OCPP 2.0 Part 2 - Errata

This document contains errata on "part 2: Specification" of the OCPP 2.0 documentation.

All these errata have been merged in the documentation, which has resulted in the release of OCPP 2.0.1.

Figure 1. Sequence Diagram: Charging with load leveling based on High Level Communication

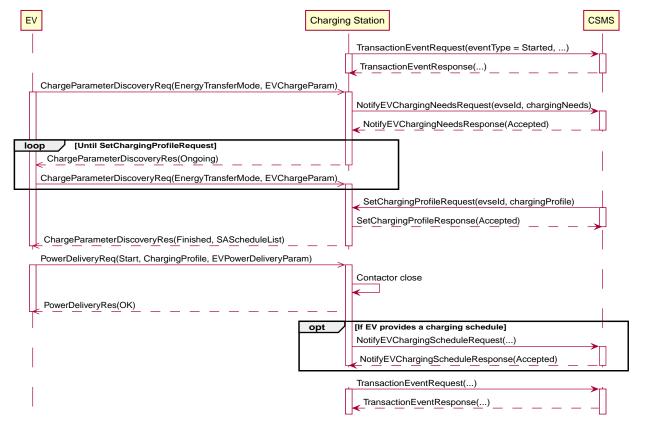
It is confusing that in order to change a charging profile, for which a CSMS will normally use SetChargingProfileRequest, it now has to send a Renegotiate15118ScheduleRequest, receive an NotifyEVChargingNeeds (which should not differ from the original, because renegotiation was initiated by CSMS) and then send a NotifyCentralChargingNeedsRequest.

Therefore we changed the use cases K15-K17 to use SetChargingProfileRequest and we updated ChargingScheduleType with an optional element *salesTariff*, so that it can provide the same information as a NotifyCentralChargingNeedsRequest message.

The following table **replaces** the requirements of use case K15:

ID	Precondition	Requirements	Note
	When the Charging Station receives charging needs from the EV	The Charging Station SHALL send a NotifyEVChargingNeedsRequest to the CSMS.	
K15.FR.02	K15.FR.01	In response to a NotifyEVChargingNeedsRequest the CSMS SHALL send a NotifyEVChargingNeedsResponse.

Figure 113. Renegotiation initiated by CSMS

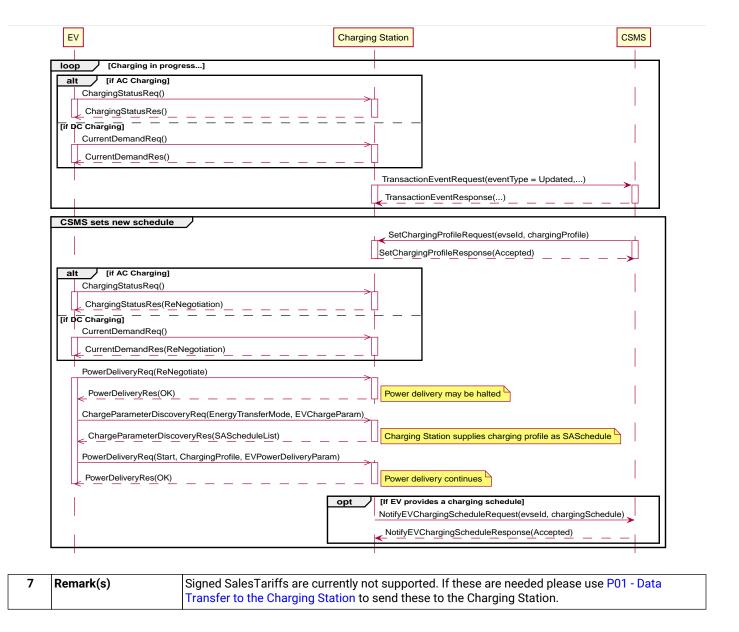
The original use case was not providing much added value compared to K15. We therefore rewrote it to specify the behavior of the CSMS providing a new charging schedule during the charging session. This is called renegotiation in ISO 15118.

No.	Туре	Description	
1	Name	Renegotiation initiated by CSMS.	
2	ID	K16	
	Functional block	K. Smart Charging	
3	Objectives	To control the charging power or current of a Charging Station	
4	Description	The CSMS sends a SetChargingProfileRequest to the Charging Station to influence the power or current drawn by the EV. The CSMS calculates a ChargingSchedule to stay within limits which	
		MAY be imposed by an external system. Note: Description of actions between EV and Charging Station is informative only and not mandated by OCPP.	
	Actors	EV, Charging Station, CSMS	
	Scenario description	1 CSMS sends a SetChargingProfileRequest to the Charging Station. 2 Charging Station responds with a SetChargingProfileResponse to the CSMS. 3 When EV sends the next CurrentDemandReq (for DC) or ChargingStatusReq (for AC), the Charging Station will respond with evseNotification = ReNegotiation. 4 EV sends a PowerDeliveryReq with chargeProgress = ReNegotiate to confirm this. 5 Charging Station responds with a PowerDeliveryRes. 6 EV sends a ChargeParameterDiscoveryReq. 7 Charging Station responds with a ChargeParameterDiscoveryRes with an SAScheduleList that contains the ChargingSchedule data from the SetChargingProfileRequest. 8 EV sends a PowerDeliveryReq with chargeProgress = Start (with an optional charging profile) to confirm this.

ID	Precondition	Requirements	NOTE
K16.FR.01	CSMS sends a new SetChargingProfileReq uest	Charging Station SHALL respond with a SetChargingProfileResponse with status = Accepted.	
K16.FR.02	K16.FR.01	Charging Station SHALL initiate schedule renegotiation with EV.	In ISO 15118 this is done by replying with EVSENotification=ReNegotiation to a CurrentDemandReq (for DC) or ChargingStatusReq (for AC) message.
K16.FR.03	K16.FR.02	Charging Station SHALL provide the ChargingSchedule data to the EV.	In ISO 15118 this is done in the ChargeParameterDiscoverRes message.
K16.FR.04	EV returns a charging profile	Charging Station SHALL verify that provided charging profile is within boundaries of the ChargingSchedule from CSMS.	In ISO 15118 EV may provide this as part of the PowerDeliveryReq message.
K16.FR.05	K16.FR.04	Charging Station SHALL send the EV charging profile in a NotifyEVChargingScheduleRequest message to CSMS.

Figure 114. Renegotiation initiated by EV

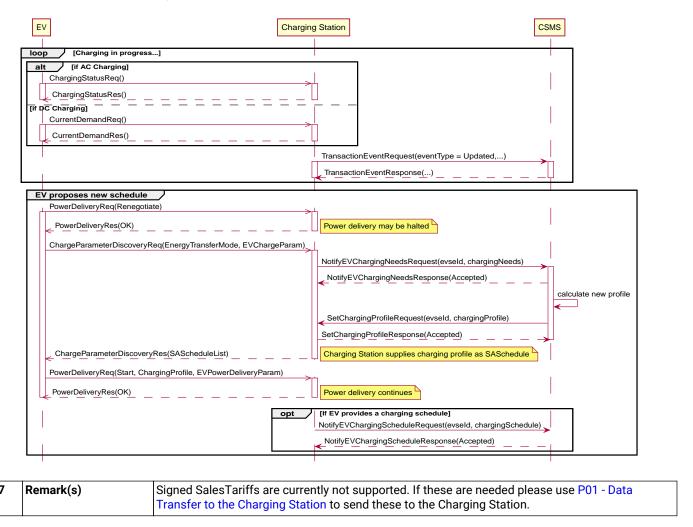
No.	Туре	Description
	Scenario description	1 When EV sends a ChargeParameterDiscoveryReq with with charging needs parameters, then
		Charging Station sends this information in a NotifyEVChargingNeedsRequest to CSMS.
		2 CSMS responds with NotifyEVChargingNeedsResponse to Charging Station.3 CSMS calculates new charging schedule, that tries to accommodate the EV charging needs and
		still fits within the schedule boundaries imposed by other parameters.
		4 CSMS sends a SetChargingProfileRequest with the new schedule to the Charging Station.
		5 Charging Station responds with SetChargingProfileResponse with status Accepted.6 Charging Station sends new charging schedule to EV in a ChargeParameterDiscoveryRes
		message. 7 EV sends a PowerDeliveryReq with chargeProgress = Start (with an optional charging profile)
		to confirm this. 8 Charging Station responds with PowerDeliveryRes and, if charging was suspended at start of

ID	Precondition	Requirements	Note
K17.FR.01	renegotiation and sends new charging needs	The Charging Station SHALL send a NotifyEVChargingNeedsRequest to the CSMS.	
K17.FR.02	K17.FR.01	In response to a NotifyEVChargingNeedsRequest the CSMS SHALL send a NotifyEVChargingNeedsResponse.	
K17.FR.03	K17.FR.02	If the CSMS is able to provide a charging schedule, it SHALL indicate this by setting the status field in the NotifyEVChargingNeedsResponse to 'Accepted'.	
K17.FR.04	K17.FR.02	If the CSMS is not able to provide a charging schedule, it SHALL indicate this by setting the status field in the NotifyEVChargingNeedsResponse to 'Rejected'.	
K17.FR.05	K17.FR.02	If the CSMS is able to provide a charging schedule; but needs processing time, it SHALL indicate this by setting the <i>status</i> field in the NotifyEVChargingNeedsResponse to 'Processing'.	
K17.FR.06		A NotifyEVChargingNeedsRequest SHALL contain either ACChargingParameters or DCChargingParameters.
